Re: Fire & Probabilistic Model Reviews - FIN A-3703

Enclosed is our review of Wisconsin Electric Power Company's (WEP) fire modeling and analyses used to justify exemption requests of their Point Beach facility to 10 CFR 50, Appendix R.

EVALUATION OF THE ANALYTICAL FIRE MODELING
BY THE WISCONSIN ELECTRIC POWER COMPANY (WEP)
IN THEIR JUNE 1982 REPORT
"POINT BEACH NUCLEAR PLANT, UNITS 1&2, RESPONSE TO 10 CFR 50, APPENDIX R
FIRE PROTECTION OF SAFE SHUTDOWN CAPABILITY"

Figure 1. Heat flux as a function of position for plume impingement on an unconfined ceiling. (From Figure 7 of Reference 4)

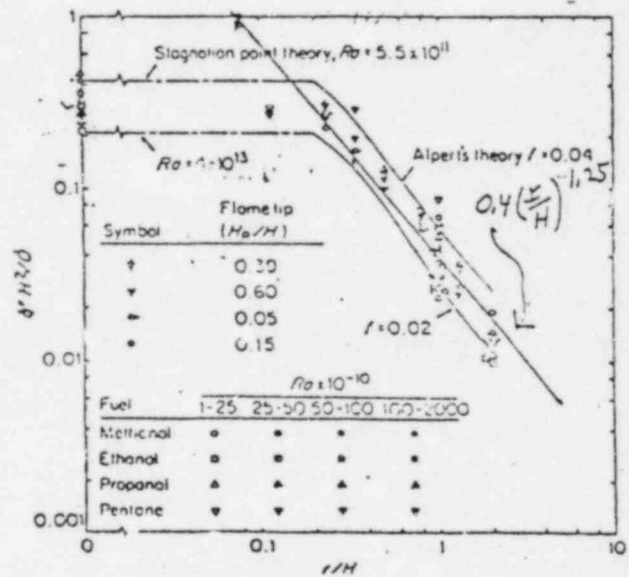
This correlation should be adequate for evaluating the heat flux due to pool exposure fires. However, it should be pointed out that one conclusion reached from the data in Reference 1 and carried over into the correlation, namely that horizontal heat flux variations are minimal, is not in agreement with some other authors²⁻⁵. In these references, data⁴ and theory^{2,3} show that, for radial distances from the fire plume axis greater than 20% of the ceiling height, the heat flux decreases with radial distance to the $-1/3$ power. However, in re-examination of Figure 7 of Reference 4, the heat flux appears to have a radial dependency to the -1.25 power. This is shown in Figure 1 provided herein. To further check this difference, we utilized the heat transfer coefficient parameter, h_c , presented by Veldman, et al (Reference 15) in their Figure 14. This shows a radial dependency for this parameter to the -0.6 power which, when applied to the $-2/3$ power correlation presented by Alpert in Reference 2 for the maximum plume temperature difference, ΔT , yields in concert a radial power law dependency of approximately (-1.27) , which is in close agreement with the -1.25 power indicated in Fig. 1.

These represent state-of-the-art correlations for hydrocarbon pool-fire plumes. However, there are several errors, most likely typographical, which should be corrected. First, the exponent of the factor F_a in the buoyancy expressions on pages A.3-2 and A.3-3 should be $2/3$ rather than $1/3$. A review of You and Faeth's work yields the following comments concerning the heat flux correlation on pages A.3-8 and A.3-9 of the submittal. The Greek symbol ν appearing in the Rayleigh number is defined as the kinematic viscosity, not the radial velocity. The heat flux correlation appearing on the bottom of page A.3-9 is valid in the ceiling jet, outside the stagnation region ($r/H > 0.2$) for free-flame height to ceiling-height ratios up to 2.5, as evidenced by the data in Figure 7 of Reference 4. The radial dependence in the correlation should be to the -1.25 power as explained in the review of Appendix A.2.
